CORRESPONDENCE

Lauzon Parkway Improvements Class Environmental Assessment Notice of Study Commencement

3. ROUNDABOUT:

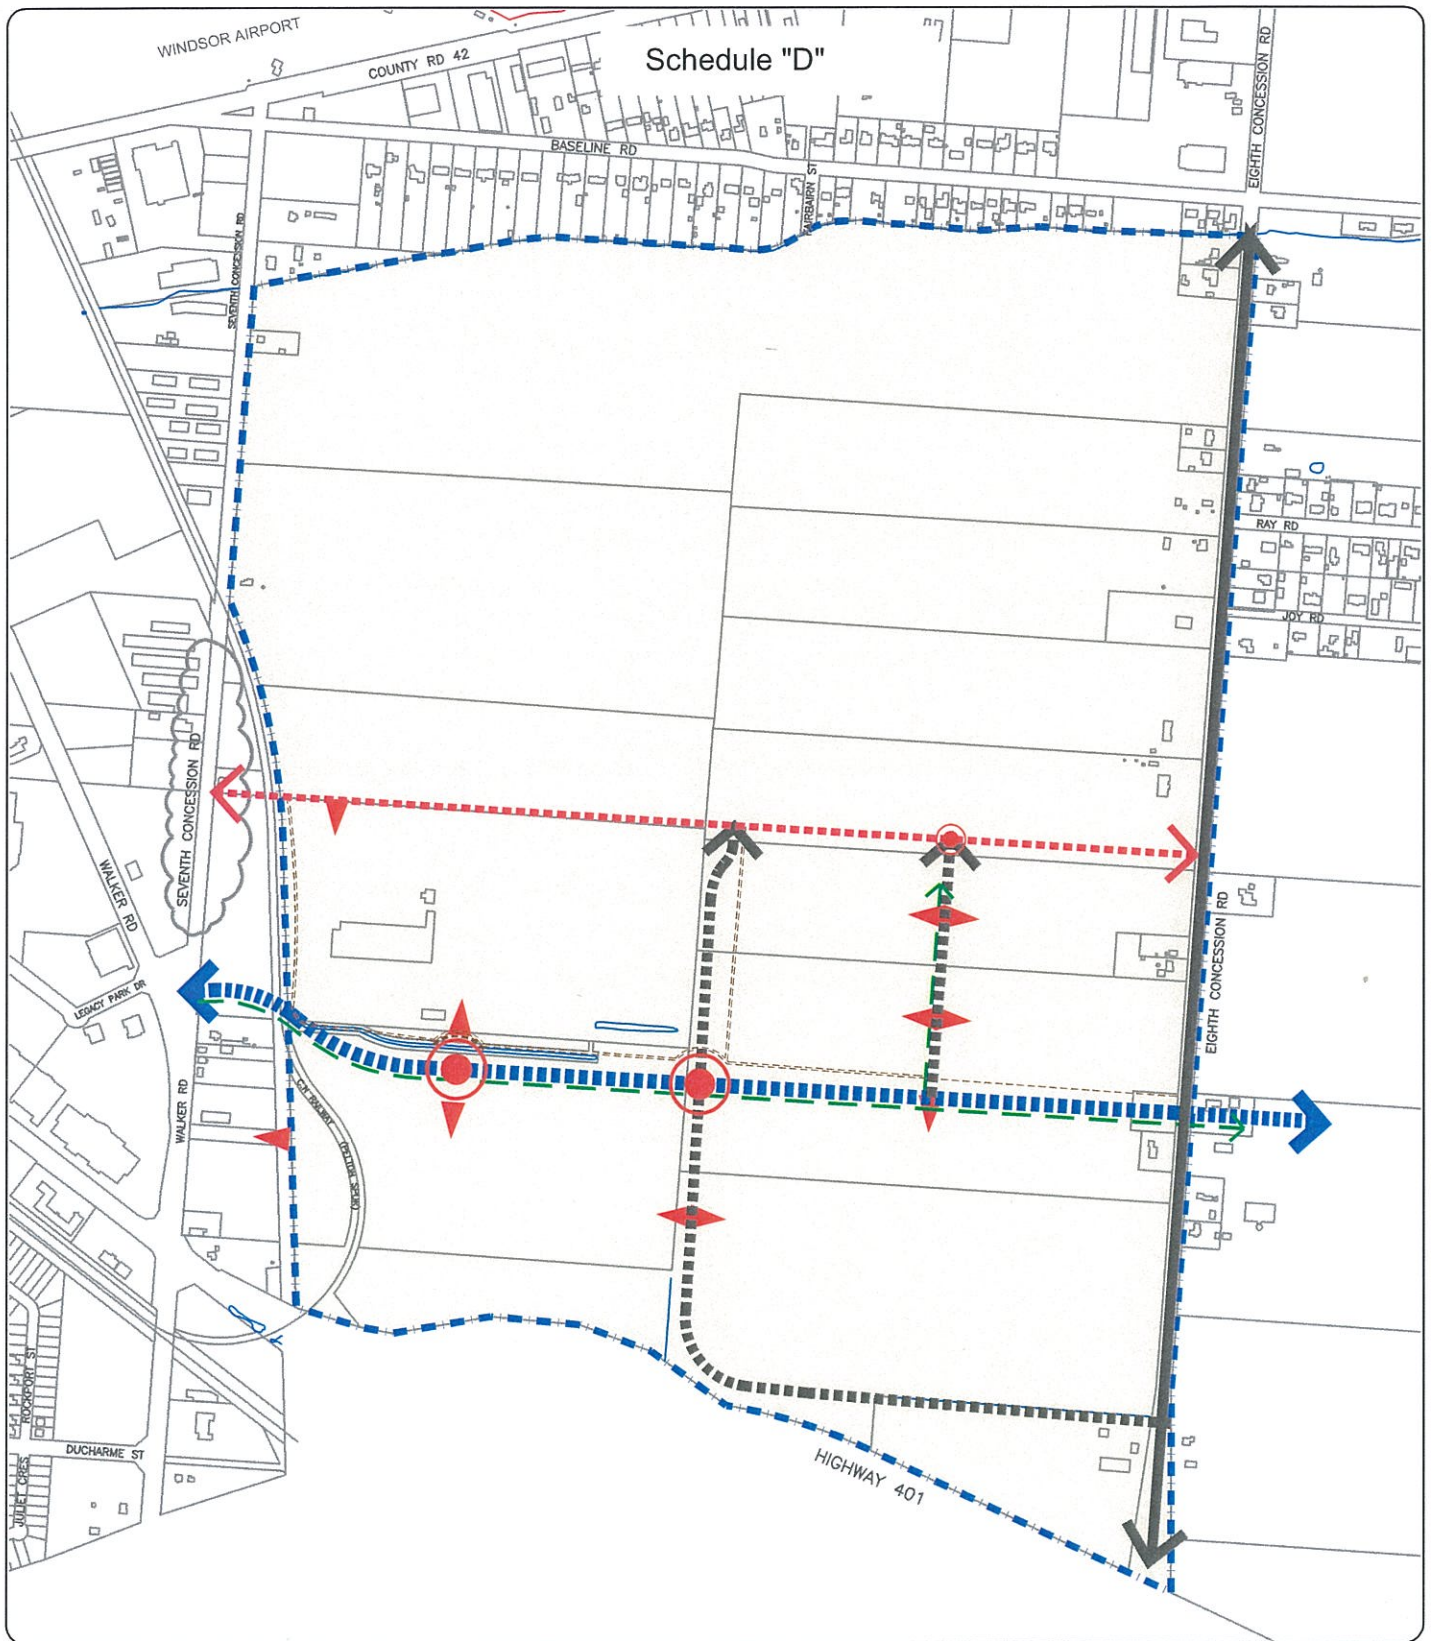
A five leg roundabout is required at the intersection of Walker Road with Legacy Park Dr. and the extension of the Legacy Parkway and 7th Concession as conceptually shown on the Stantec plan.

Figure 3.1 – Proposed Conceptual Roundabout Configuration

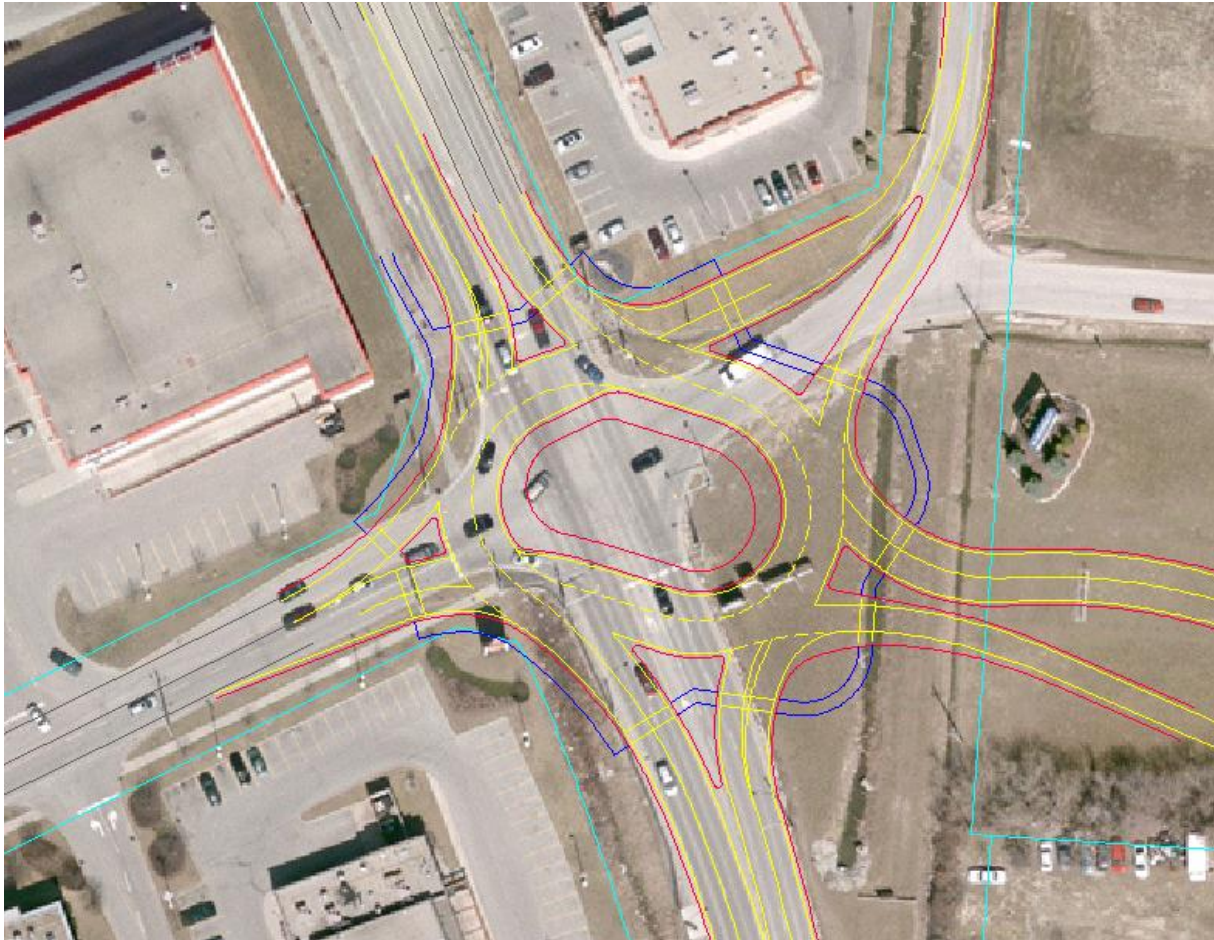
The roundabout concept as depicted in **Figure 3.1** does require heavy vehicles to occupy both lanes of the roundabout as is the common practice. As noted earlier, design refinements would be required should the concept be explored further such as:

Exhibit 1: Screenshot from VISSIM Software for Proposed Condition

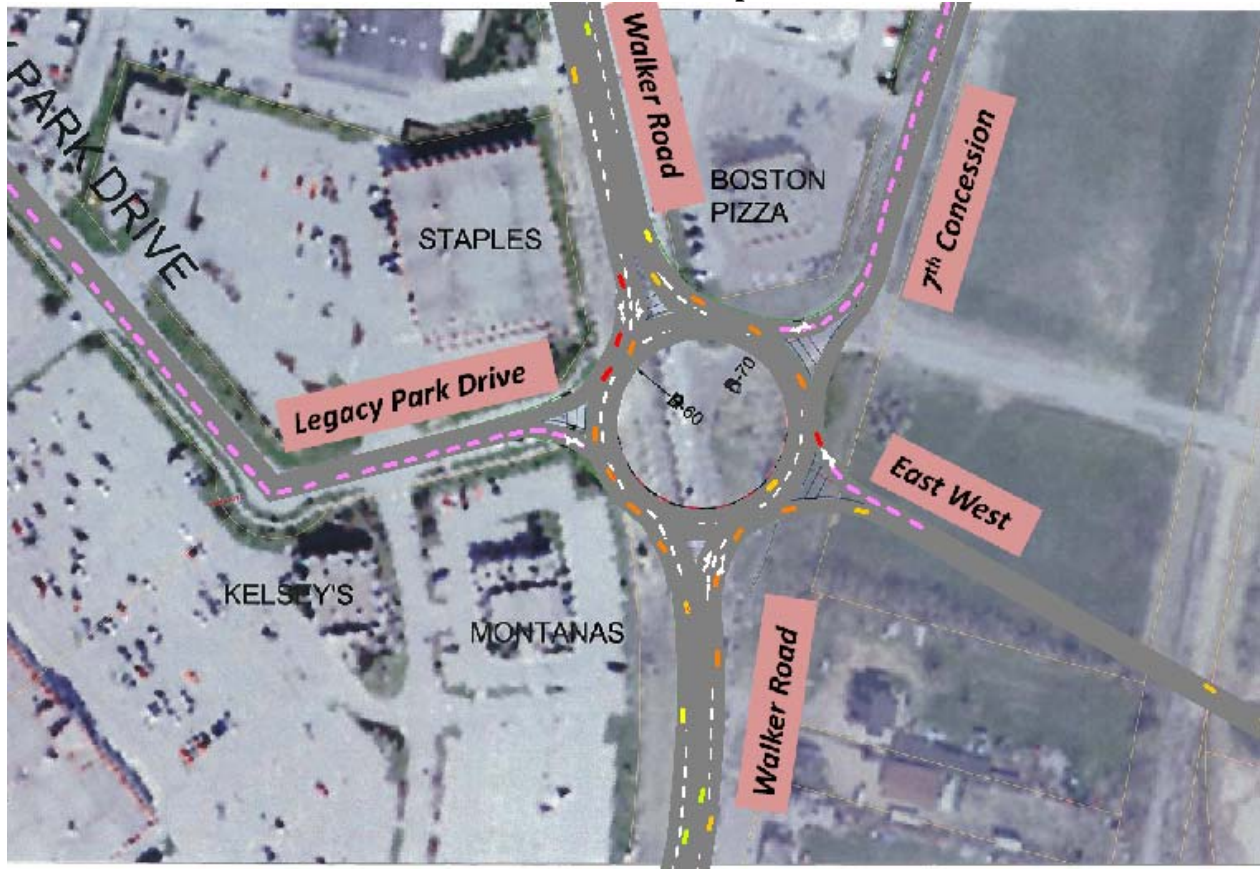
The screenshot from the VISSIM microsimulation is presented in **Exhibit 1**; demonstrates the long queues (high delay) for the 7th Concession Road and Legacy Park Drive.

In addition to capacity constraints on approaches, the proposed roundabout would result in other traffic operational issues with respect to:

Figure 1 - Roundabout Layout

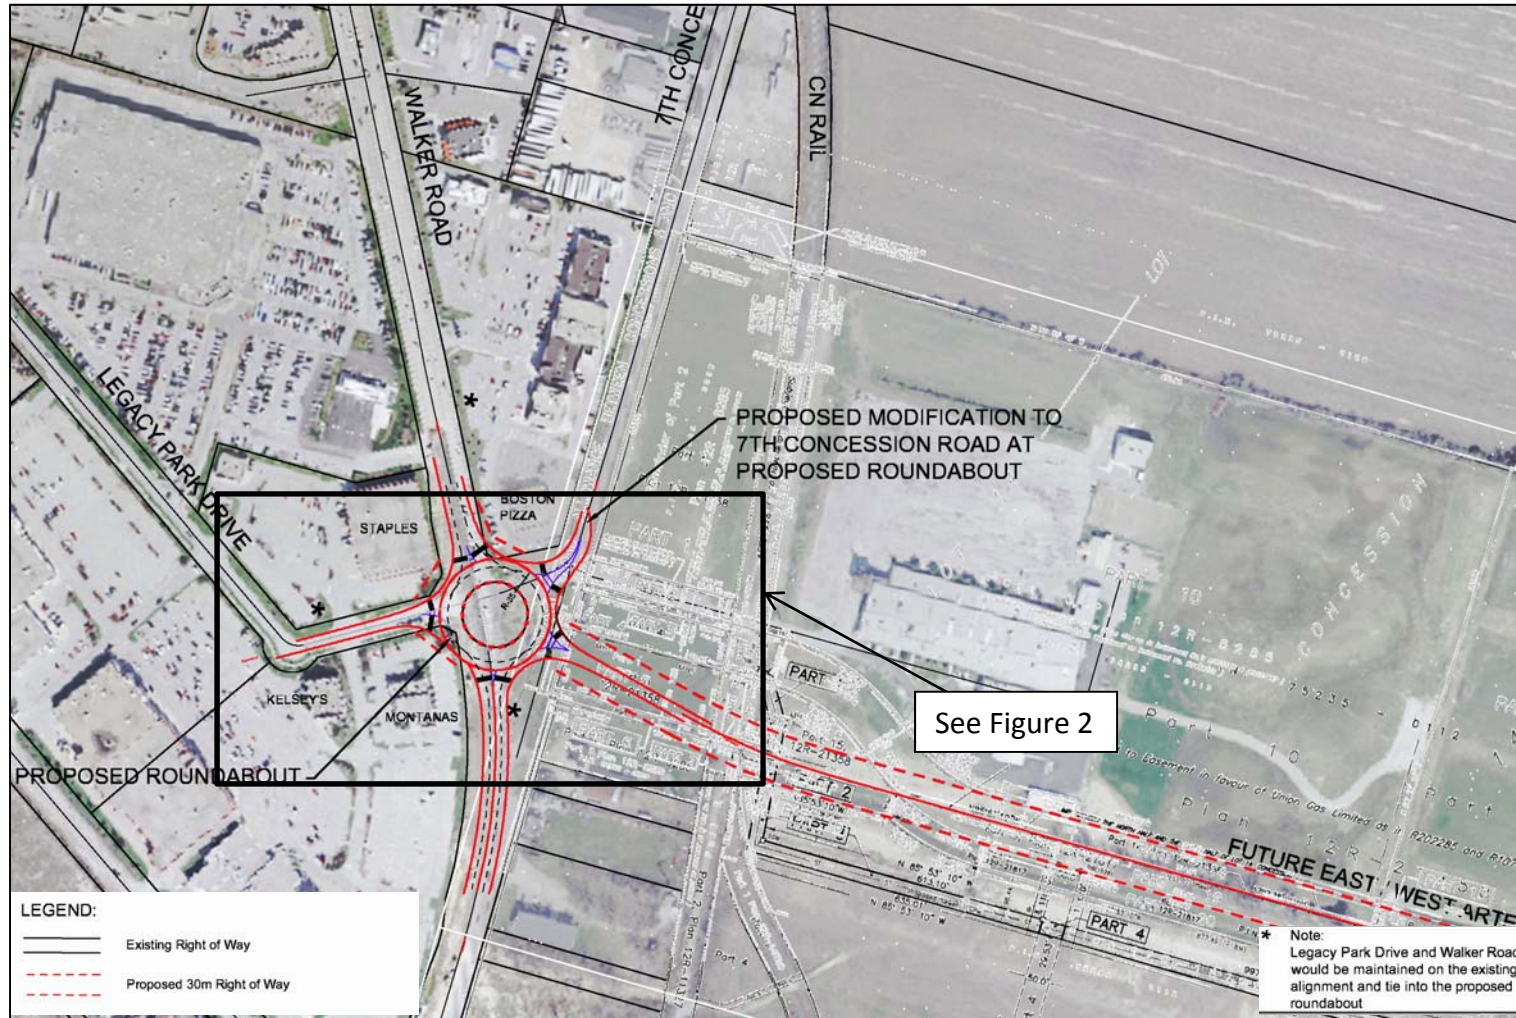
As shown in Figure 1, the roundabout option would maintain access from all intersecting roads, which would result in a 5-leg roundabout. The roundabout would be 2 lanes with an inscribed diameter of 70 m. Due to the high truck volume, the roundabout would be required to accommodate truck traffic (WB-20.5). The existing share of commercial vehicles on Walker Road during the a.m. peak hour is approximately 8 to 10% and during the p.m. peak hour is approximately 5%.

The design configuration used in the traffic operational analysis is presented in **Figure 1**. The intersection capacity analysis for the roundabouts was assessed using three traffic engineering software: (1) Arcady, (2) SimTraffic/Synchro and (3) VISSIM.

Figure 2 - Roundabout Layout

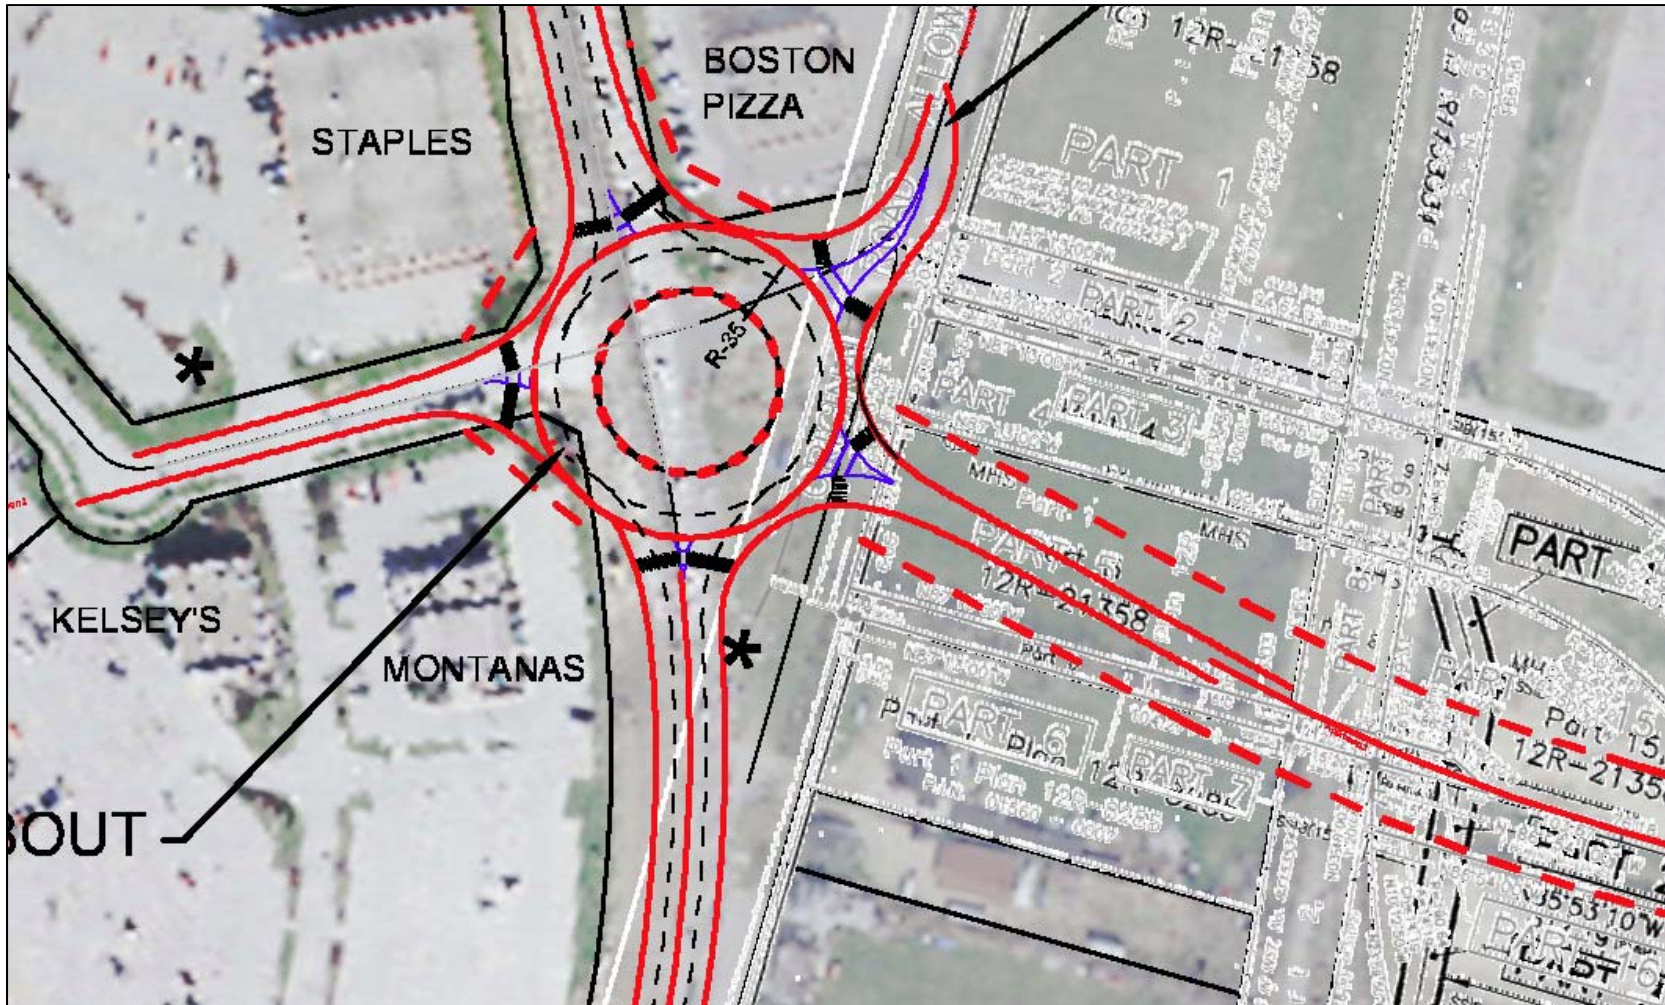
It should be noted that Figure 2 represents only a planning level of the roundabout. Details such as cycling and pedestrian requirements have not been included; therefore, property impacts may be more significant than shown.
